Access Compliance Report

Public Rights-of-Way

(Curb Ramps)

Intersection ID: 30015	Main Street: MOORGATE_RD	Cross Street: YEARWOOD_LN	Location: SW
ADA ID: 8F389C383866	Ramp Type: Perpendicular Diagonal	Initial Pass/Fail: Fail	Overall Compliance: No
		Severity Score: 8.75

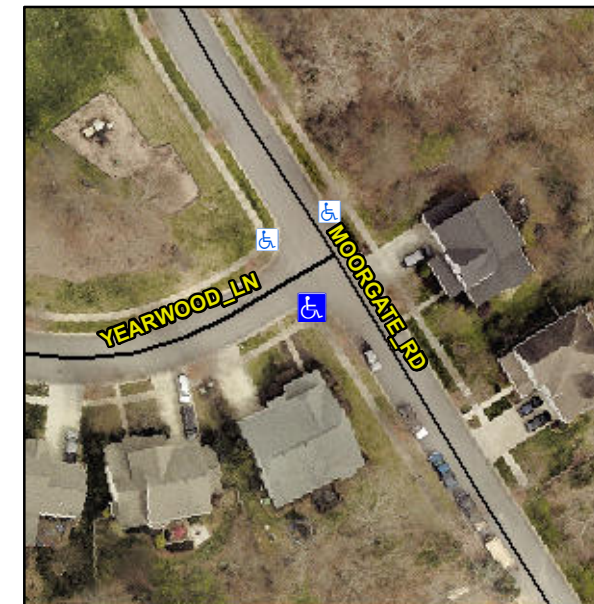
Not Found, R304.5.1

Compliance	Description	Data	Compliance	Description	Data
N/A	Ramp Length (in)	69.0	Yes	Ramp Slope (%)	6.1
No	Ramp Width (in)	37.0	Yes	Ramp XSlope (%)	1.8
N/A	Flare Type LT	N/A	N/A	Flare Type RT	N/A
N/A	Flare Slope LT (%)	N/A	N/A	Flare Slope RT (%)	N/A
N/A	Flare Traversable LT?	N/A	N/A	Flare Traversable RT?	N/A
N/A	Landing Length (in)	N/A	N/A	DWS Provided?	N/A
N/A	Landing Width (in)	N/A	N/A	DWS Contrast?	N/A
N/A	Landing Slope (%)	N/A	N/A	DWS Length (in)	N/A
N/A	Landing X Slope (%)	N/A	N/A	DWS Full Width?	N/A
N/A	Landing Curb? (Y/N)	N/A	N/A	DWS Offset (in)	N/A
N/A	Shared Landing?	N/A			
N/A	Gutter Ponding?	N/A	N/A	Gutter Slope (%)	N/A
N/A	Gutter Lip Ht (in)	2.0	N/A	Gutter X Slope (%)	N/A
N/A	Painted X Walk1?	No	N/A	Painted X Walk2?	No
	X Walk 1 Direction	To E		X Walk 2 Direction	To N
N/A	X Walk 1 Width (in)	N/A	N/A	X Walk 2 Width (in)	N/A
	X Walk 1 Slope (%)	1.6		X Walk 2 Slope (%)	4.5
	X Walk 1 X Slope (%)	2.4		X Walk 2 X Slope (%)	1.8

Remove & Replace Curb Ramp With Two New Directional Ramps or Equivalent.
